MIL-H-1237C
AMENDMENT - 2
20 October 1967

MILITARY SPECIFICATION

HINGES, BUTT (FOR SHIPBOARD USE)

This amendment forms a part of Military Specification MIL-H-1237C, dated 26 March 1962, and is mandatory for use by all Departments and Agencies of the Department of Defense.

FIGURE 5 - LAYOUT OF TYPE II, CLASS 1, STYLE B, $3\frac{1}{2}$"X3" HINGE FOR METAL JOINER DOORS

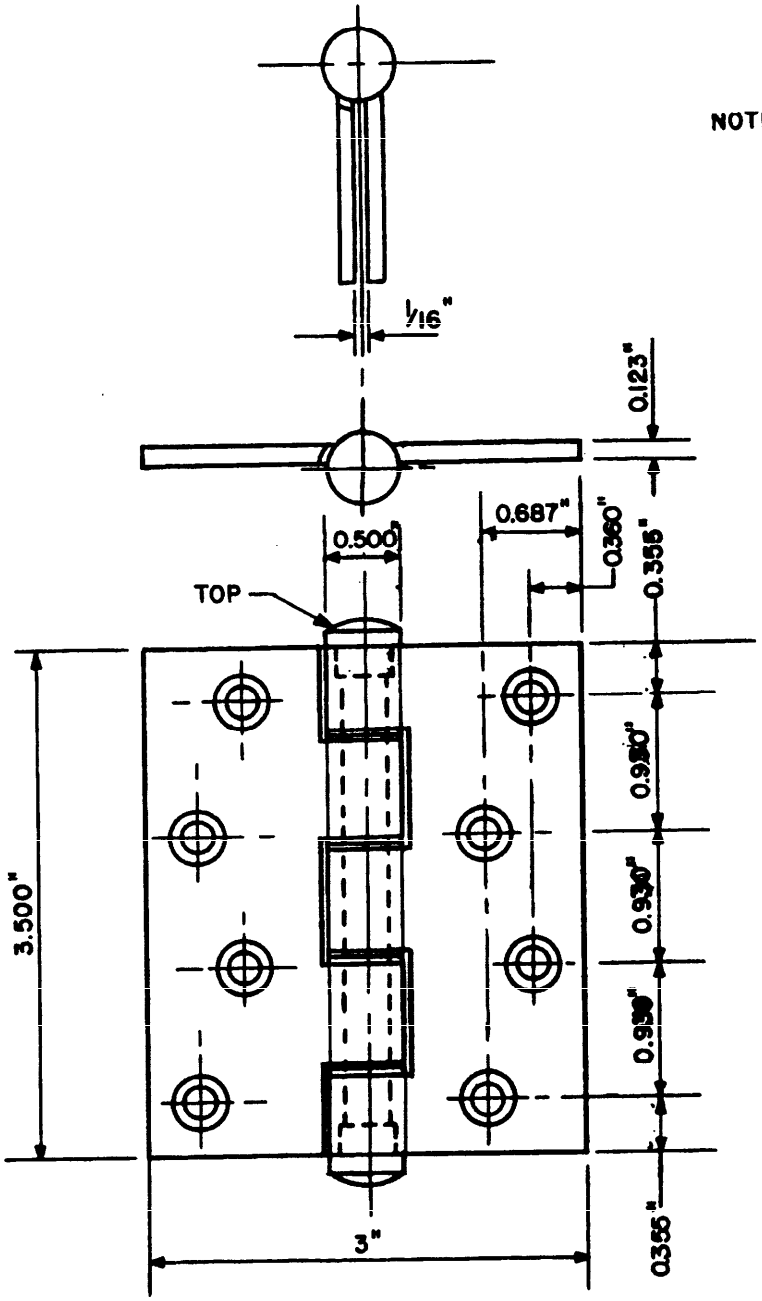
Page 6, add new paragraph 3.11.1:

Add Figure 5.

"3.11.1 Type II, class 1, style B, $3\frac{1}{2}$ x 3 inch hinges, when ordered for metal joiner doors, shall be fitted with nylon shoulder bushings in each knuckle and shall be drilled for eight No. 10-24 screws in accordance with Figure 5. Screws shall be No. 10-24 UNC 2, flat undercut-head, $\frac{1}{2}$ inch long, brass, dull chrome US 26D finish."
